**PROPOSED MODIFIED EXPRESS TERMS
FOR
BUILDING STANDARDS
OF THE
CALIFORNIA STATE LANDS COMMISSION**

**REGARDING AMENDMENTS TO
CHAPTER 31F, MARINE OIL TERMINALS
2007 CALIFORNIA CODE OF REGULATIONS, TITLE 24, PART 2**

The CSLC has proposed changes to ninety-one (91) sections during the first comment period from 12/26/08 through 02/24/09. Pursuant to the comments received, changes were made to seven (7) sections of those originally proposed express terms. The second comment period was observed from 09/16/09 through 09/30/09 and no comments were received during this period. However, late comments are addressed in the Final Statement of Reasons.

FIGURE 31F-2-1

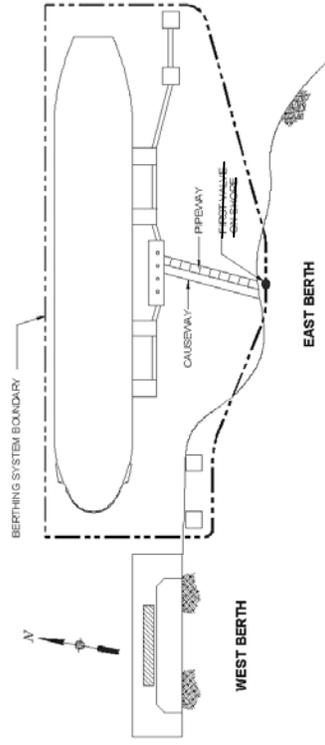
16. 3102F.3.6.1 Terminal Operating Limits. Figure 31F-2-1

MAX. MIN. DRAFT (BALLAST CONDITION) FREEBOARD AT BERTH _____ WITH UNDERBEL CLEARANCE OF _____ (FROM OPERATOR MANUAL)

FIGURE 31F-3-1 - DESIGN ACCELERATION RESPONSE SPECTRA FOR THE PORTS OF LOS ANGELES AND LONG BEACH, 475 YEAR RETURN PERIOD (5% Critical Damping)

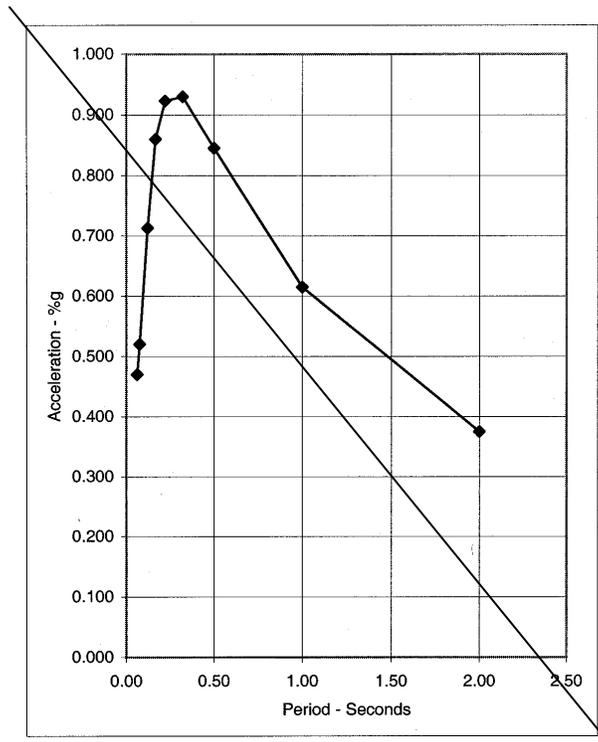
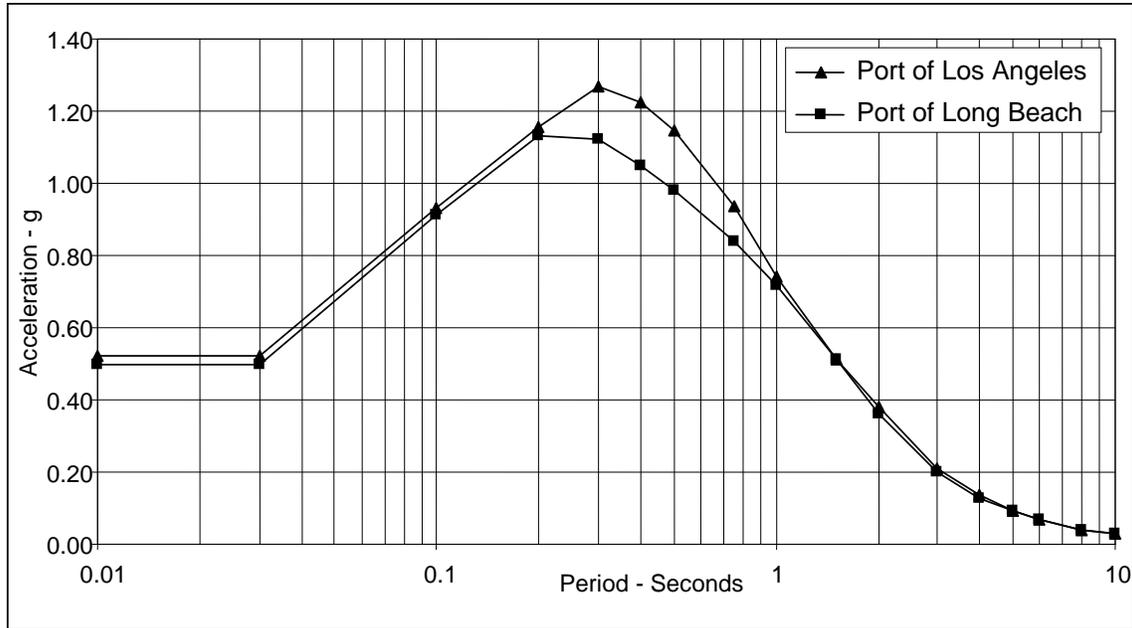
PSHA have been developed for the Ports of Los Angeles and Long Beach [3.5, 3.6] and provide site-specific information for seismic analyses. Table 31F-3-3 provides response spectra, for a 475 year return period earthquake and 5% critical damping. Figure 31F-3-1 provides the corresponding spectra for the two ports. Additionally, these references provide spectra for return periods from 72 to 2,500 years.

20. **3103F.4.2.3 Earthquake Motions from Site-Specific Probabilistic Seismic Hazard Analyses.**
Figure 31F-3-1

Figure 31F-3-1 Response Spectra for the Ports of Los Angeles and Long Beach, 475 Year Return Period (5% Critical Damping)

Figure 31F-4-4--Design Displacement Response Spectra

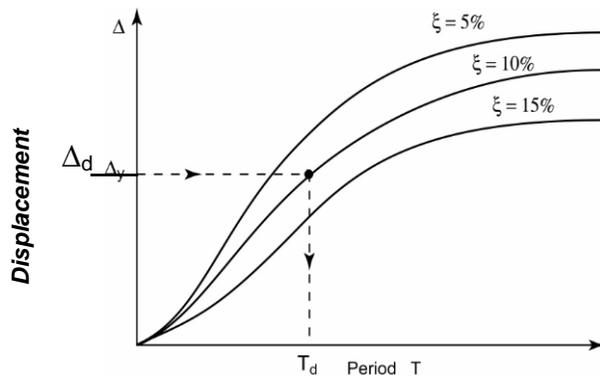
48. 3104F.2.3.2.5 Refined Analyses.
